**SSD5093 – North Ryde Station Precinct “M2 Site”
Response to Transport for NSW Submission**

Review of TfNSW Spine Road Lane Width Recommendation

FIGURE 1 – BUS ZONE ON PARK STREET (SOURCE: DRAWING C-0-5-0-4, ROBERT BIRD GROUP)

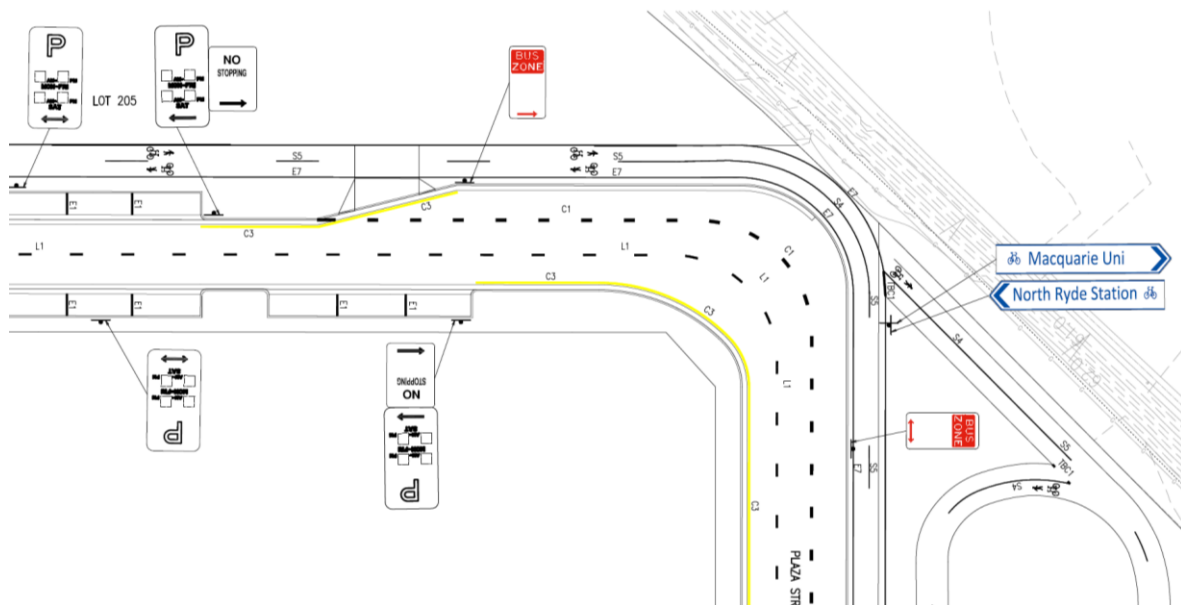
TfNSW requests written conformation and an updated diagram that confirms that the three bus bays in the retail precinct are capable of accommodating an articulated vehicle. Signs and Line Marking Drawing C-0-5-0-4 prepared by Robert Bird Group submitted with the Response to Submissions shows the bus zone sign and line marking proposed on Park Street. Refer to drawing extract at Figure 1.

It is confirmed that the three bus bays provided in the retail precinct on Park Street and Plaza Street are designed to accommodate articulated buses and appropriate signs and line marking were provided on the civil drawings that accompanied the Proponent's Response to Submissions report.

- **SSDA *Plan C-0-3- 40 Swept Path Analysis Plan Sheet 1 of 2***

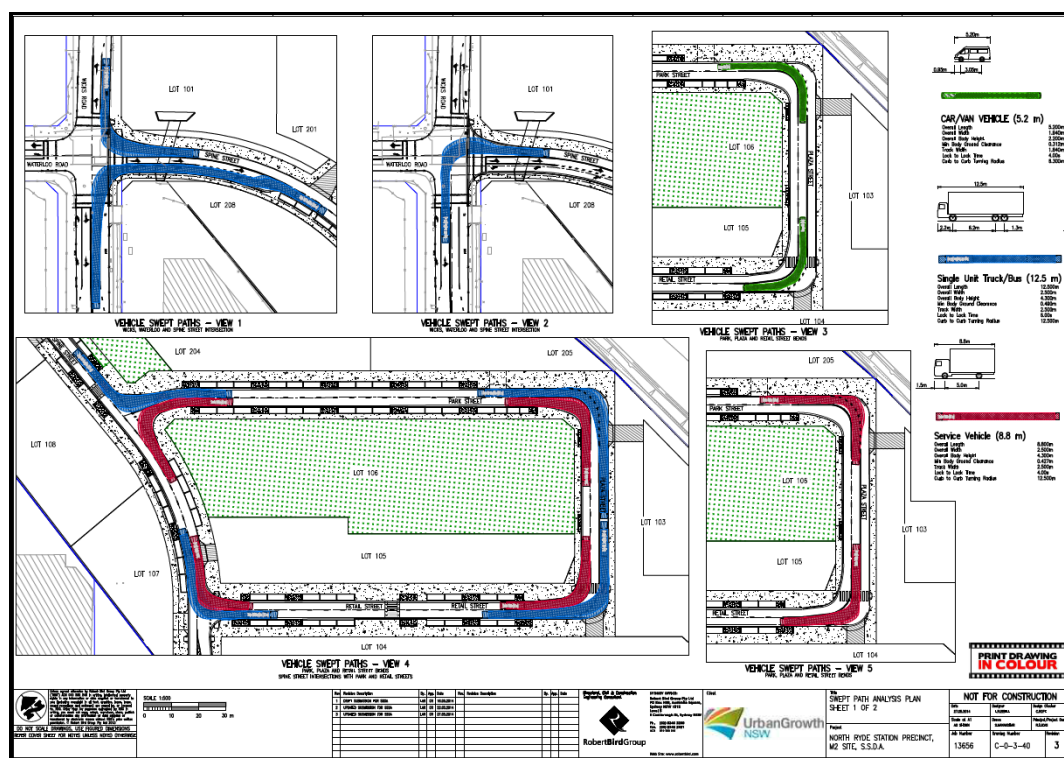
- The proponent demonstrates how articulated buses can safely traverse the site given the advised minimum width for new bus capable roads is 3.5 metres.

Notwithstanding the above – and with specific reference to the TfNSW *Recommendation* - the movement of an articulated bus through the M2 Site was also assessed as part of the SSDA process, and it has been determined that an articulated bus – which critically again is not the design vehicle with reference to the STA BIG Section 2.3 – can move through the M2 Site with relatively minimal lane sharing.

Many of the key turning movements shown in the SSDA *Plan C-0-3- 40 Swept Path Analysis Plan Sheet 1 of 2* required design changes to specifically facilitate these 12.5m bus template turning paths, including 'flattening' kerb radii at key locations, but nonetheless the M2 Site – and specifically the Spine Road - provides for the movement of 12.5m buses with a turning radius of 12.5m as per the requirements of the STA BIG; and utilising 3.25m lane widths as per the requirements of the NRSP TMAP, the NRSP DCP, the STA BIG and the RTA RDG.

However - and critically - the analysis of the articulated bus movements also shows that lane sharing by an articulated bus would occur regardless of the width of the lanes, i.e. there would be no significant difference between the lane sharing to/from a Spine Road with lane widths of 3.25m, or a Spine Road with lane widths of 3.5m.
